## SUNDRY NOTICES AND REPORTS ON WELLS

UTE MNT TRIBAL J # 01

**P&A Procedure**

**Conditions of Approval - Notice of Intent to Abandon:**

# P&A'D WBD

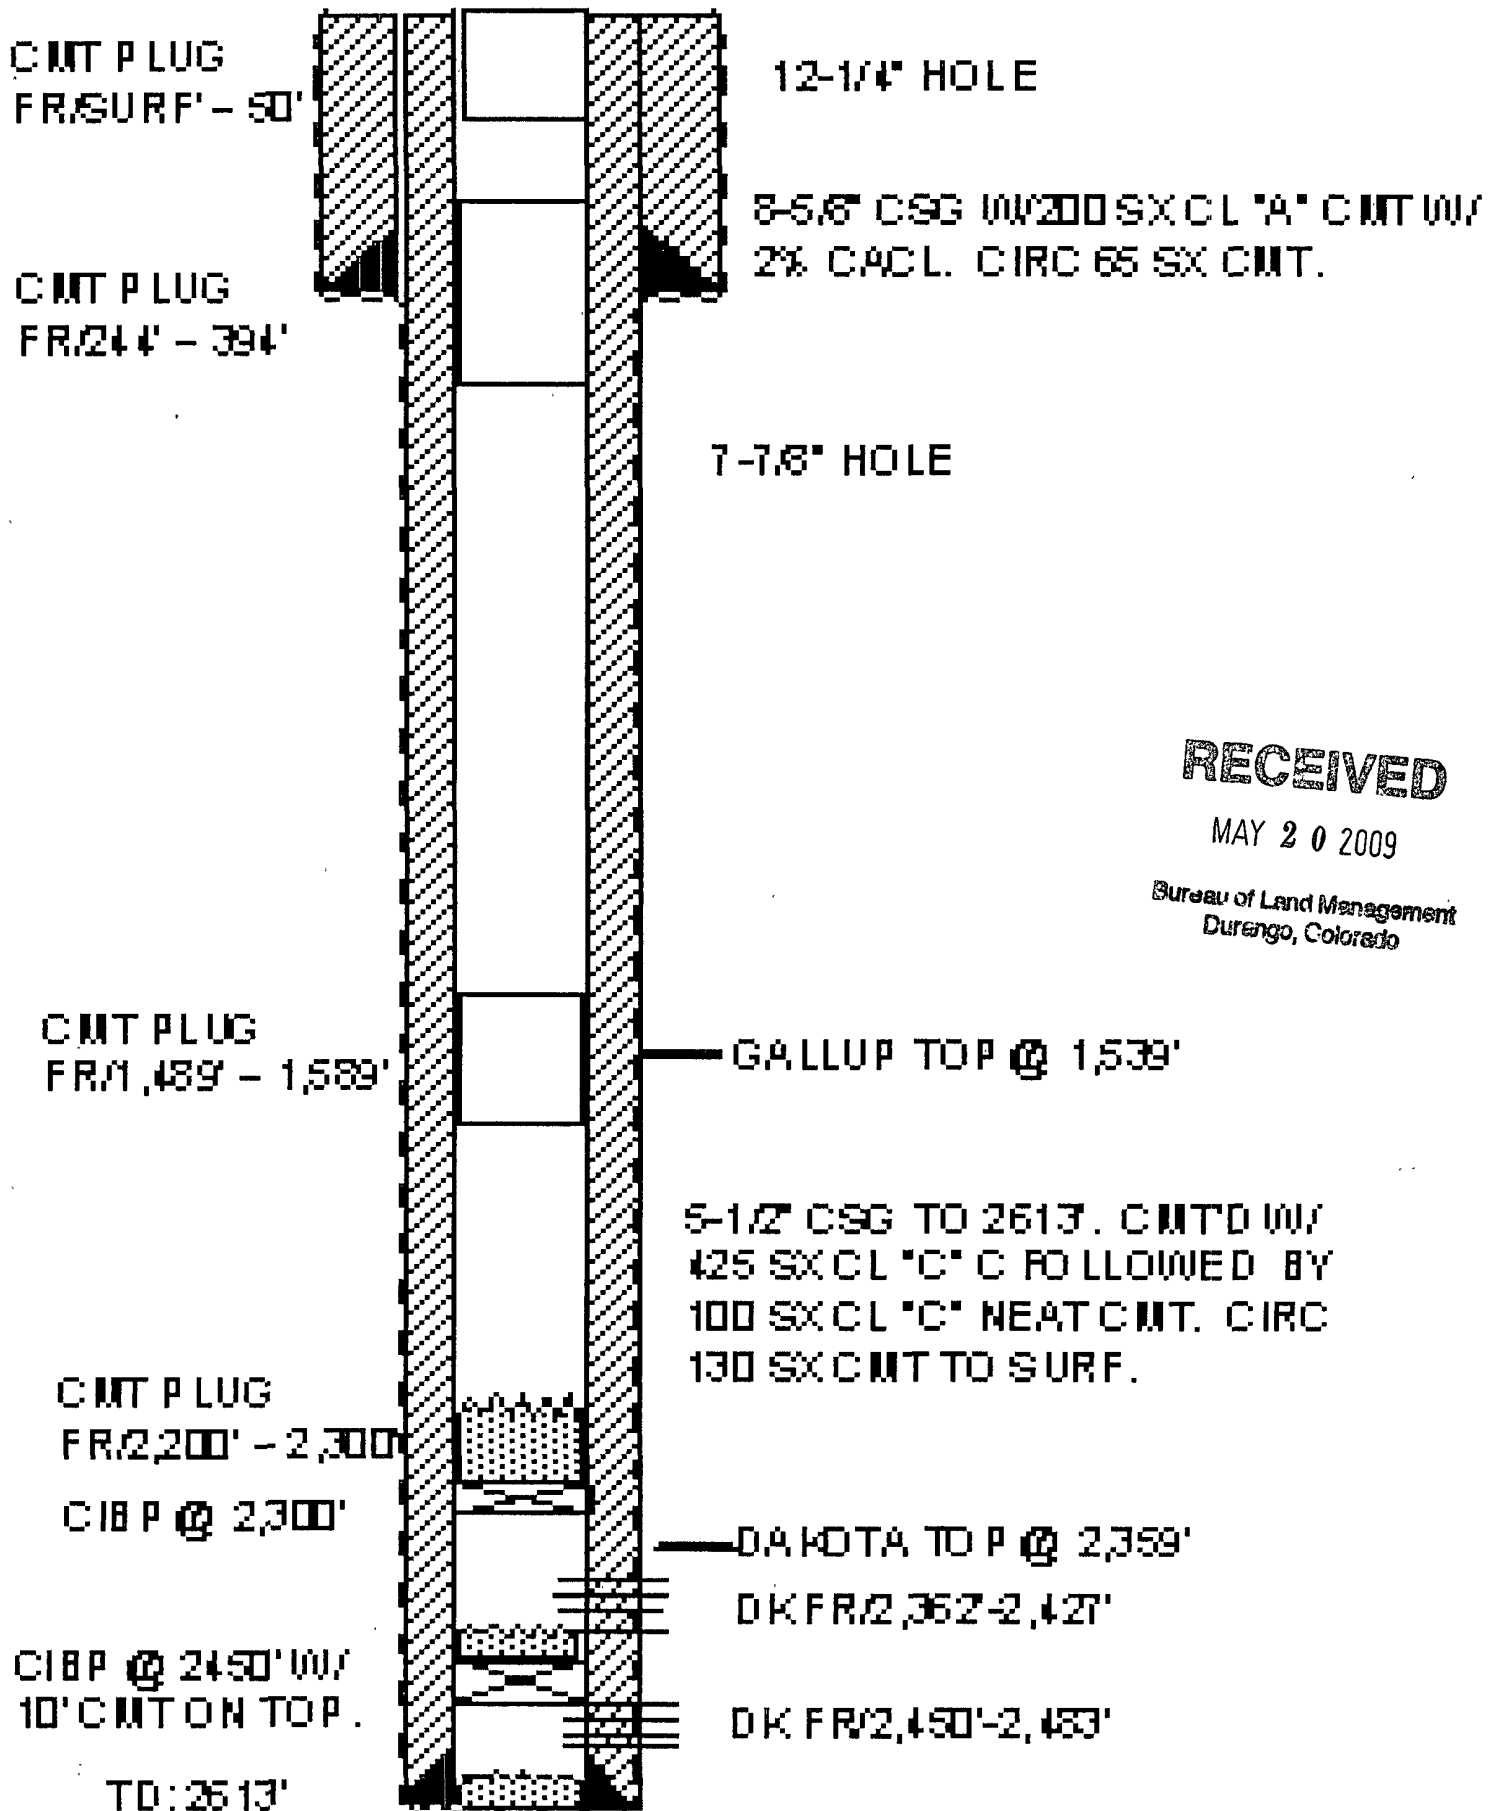
**All plugs with the exception of the Surface plug must be a minimum of 25 sacks of cement as per Onshore Order #2, III, G,1, iii.**

- 6d. All plugs with the exception of the Surface plug must be a minimum of 25 sacks of cement as per Onshore Order #2, III, G,1, iii.
  - 6e. Combine the plug from 244' to 394' with the surface plug to form one large plug.
